1968 Corvette: Service Bulletin: General Information

Bulletin No: 68-T-43

Date: April 24, 1968

GENERAL INFORMATION

Astro Ventilation - Poor Air Flow

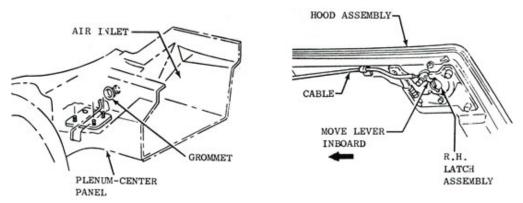
The amount of air flow through the Astro Ventilation System may be restricted if the flapper type valves are improperly cemented to the valve frame. These valves are located under the rear deck and should swing freely as pressure builds up in the passenger compartment.

In instances where the valve action is restricted, separate the rubber flaps from the frame along the bottom and sides. The Astro Vent ducting and cowl kick pad vents should also be checked for leakage as this will reduce air flow at the nozzles.

Rear Bow Lock Remote Control Cable Rattle

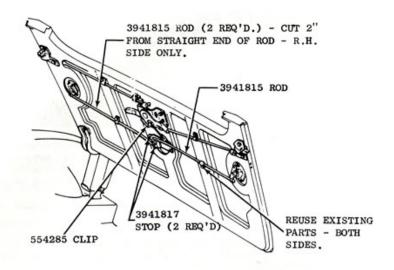
Remote control cables used on early 1968 Corvette Convertible models could rattle against the rear compartment lid. Production replaced these cables with rods on 1/2/68.

Complaint vehicles may be updated by installing the rear bow lock remote control rods as indicated on the sketch below.
